REQUEST

Current Zoning: NC (neighborhood center), N1-D (neighborhood 1-D), and O-6(CD) (office, conditional)
 Proposed Zoning: CAC-1 (EX) (community activity center 1, exception)

Approximately 2.839 acres bound by the south side of Central Avenue, west side of Piedmont Street, north side of Sunnyside Avenue, and east side of the Independence/I-277 Ramp.

Central Avenue Multifamily, LLC

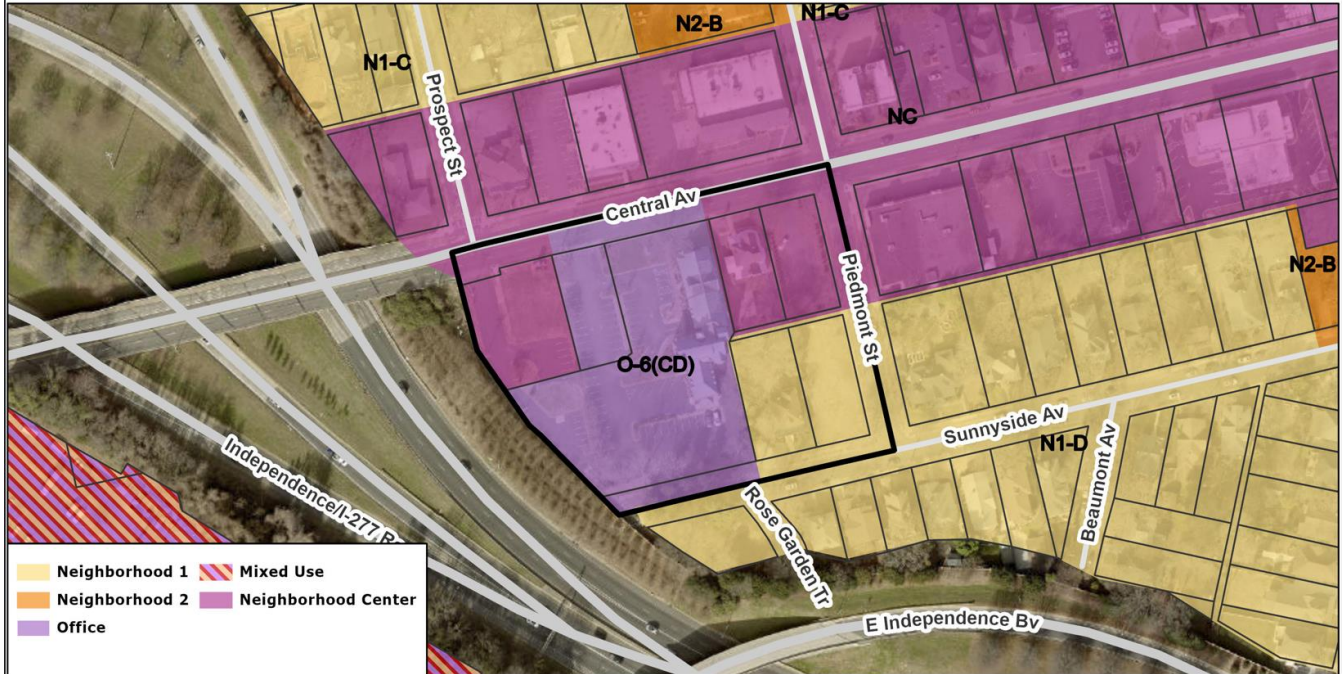
- Proposes up to ~~315~~ **295** residential units and a minimum of ~~1,500~~ **2,500**, up to 5,000, square feet of commercial and retail uses unrelated to the multi-family development.

- City Improvement EX Benefit Category: The petitioner commits to construct a publicly accessible shared-use path along the western property boundaries. ~~The existing sewer line along the western edge between Central Avenue and Sunnyside Avenue would be relocated. The relocated sanitary sewer shall not be placed within 10 feet of the edge of the LYNX Silver Line infrastructure.~~ The plan specifies reservation of ROW and an associated temporary construction easement for future acquisition by CATS for the LYNX Silver Line.

- **Sustainability EX Benefit Category: The petitioner commits to use National Green Building Standards (NGBS) Bronze or an equivalent standard.**
 - EX Provision to Article 11.3.B regarding building height standards: requests to modify the allowed building height for structures within 200' of the Neighborhood 1 Place Type for the northeastern corner of the site and a portion of the site's western boundary from 65' maximum building height to **85' 70'**.

- Specifies an 8' planting strip and 8' sidewalk along Piedmont Street and Sunnyside Avenue.
- Provides a minimum of ~~750~~ **1,500** square feet of improved public open space at the corner of Piedmont Street and Sunnyside Avenue.
